MEMORANDUM

Re: **HMH Carrier Clinic, Inc.**
Preliminary and Final Major Site Plan and Bulk Variances
Revised Application Submission
252 County Route 601
Block 2001, Lot 2
Block 1001, Lot 14.02
MR Mountain Residential Zone

Date: January 18, 2024

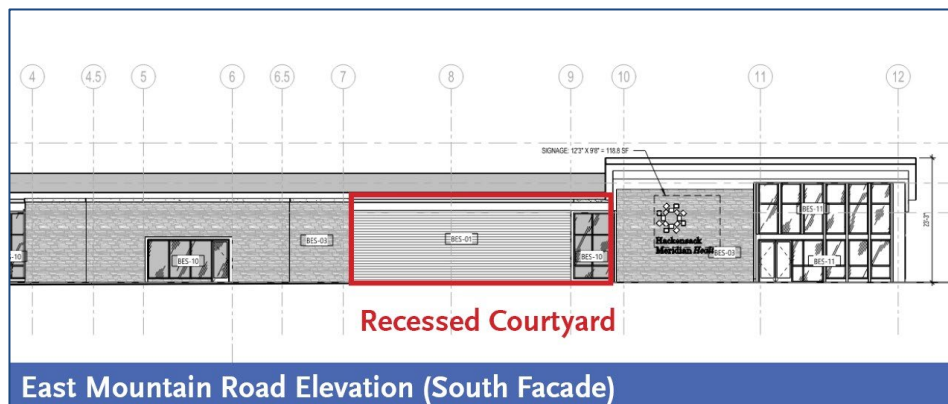
- 10.2 **Unidentified Façade Material:** The 3D architectural renderings suggest the use of a wood or faux wood material at the main entrances to each proposed building addition. This material does not appear to be identified in the architectural elevations. **It is recommended that the plans be revised to identify the wood-like material shown in the 3D architectural rendering.**
